Updates to the Rhode Island Statewide Total Maximum Daily Load (TMDL) for Bacteria Impaired Waters

**Final Report
September 2023**

Section 6.0 Response to Comments Received During the Public Comment Period

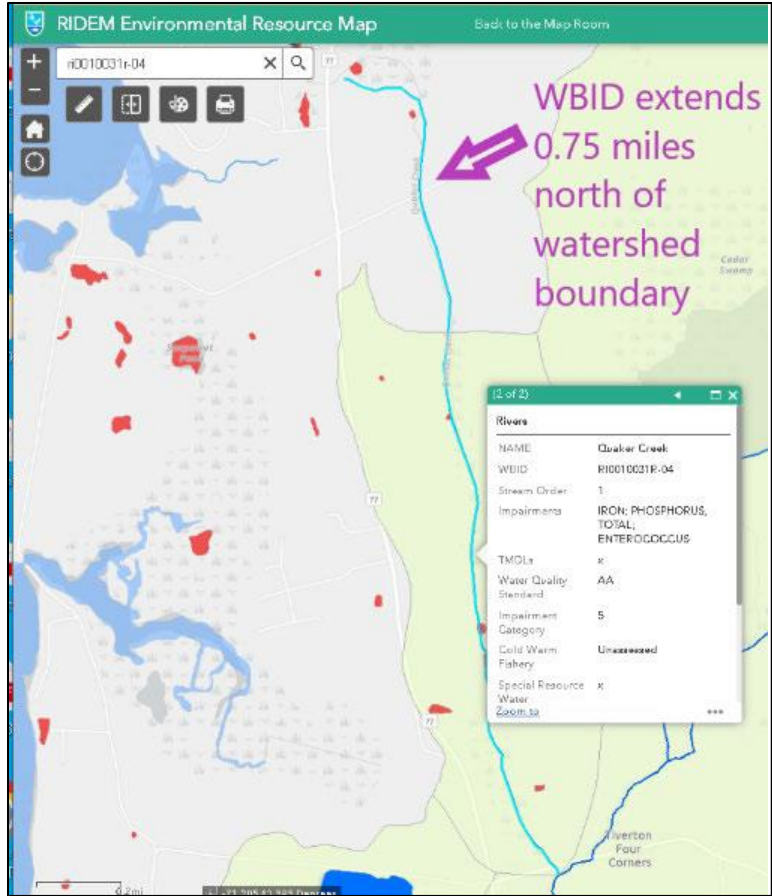
17. Landfill contributions should have its own section under "Exceedances and Potential Sources." According to the TMDL documentation for the City of Newport Reservoirs (RIDEM, 2021), “The landfill swale is a stormwater conveyance to Quaker Creek and is therefore considered to be a point source to a water of the state.” Additionally, “the landfill swale was documented to convey leachate containing TSS, ammonia, and dissolved organic carbon (DOC) during dry weather. Stormwater runoff from the upper portions of the landfill during wet weather is elevated in TSS, total phosphorus, total nitrogen (primarily as ammonia), DOC, and Enterococci. Actions to mitigate this point source should be addressed explicitly within this documentation.

The Tiverton Landfill is currently undergoing the final closure and capping process within the licensing program of RIDEM’s Office of Land Revitalization and Materials Management. It is expected that the process will be complete by September 2023. The RIPDES permit is expected to be issued following the completion of the closure and capping. The final closure and capping of the landfill will manage any stormwater or other discharges from the landfill that could impact Quaker Creek. No changes have been made to the document.

Figure 1: Enterococci Freshwater Rivers and Streams Daily Loads

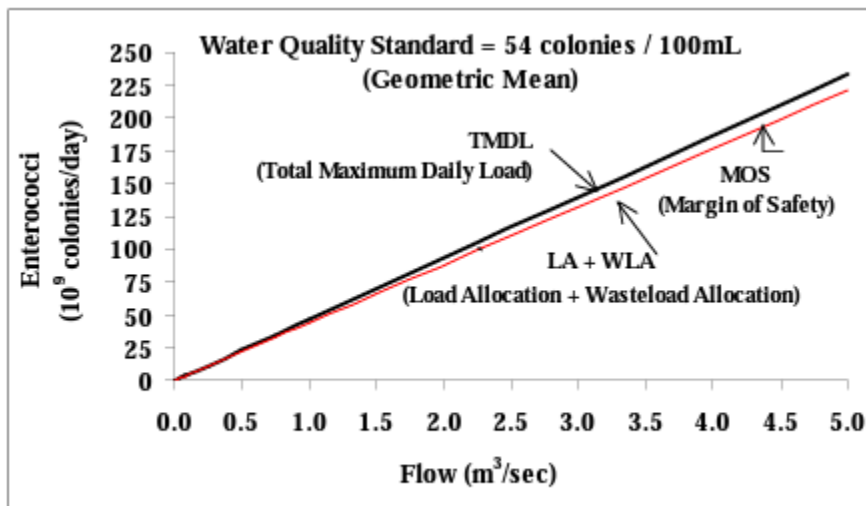
35. How can waste load allocations be calculated without flow data? Flow data is required to make load reductions meaningful. High concentrations from small volume sources have little impact on receiving waters. For example: a high concentration of bacteria from isolated pet waste is less of a concern than a manure pile that may have a volume of hundreds of cubic yards of potential load. Both sources may result in an individual sample concentration value that has bacteria concentrations above reporting limits or that are too numerous to count using standard analysis techniques. Removing large loads would be more protective of the resource than reducing high concentrations from minor sources.

Bacteria TMDLs use concentration data rather than loading data to determine allocations and what is necessary to achieve criteria. As stated in the Statewide Bacteria Core Document, expressing bacteria TMDLs in terms of concentration provides a direct link between existing water quality and numeric water quality criteria, consistent with water quality standards which apply for a range of flow and environmental conditions, and loads for bacteria can difficult to interpret.

Additionally, in the Statewide Bacteria Core Document, Appendix M provides a means to express the concentration targets as daily loads. Figure 1 and Table 1 from Appendix M (reproduced below) provide a general cross-walk for flows between 0.0 and 5.0 m³/sec. For flows >5 m³/sec Formula 1 (reproduced below on next page) can be used. Full details are documented in Appendix M³.
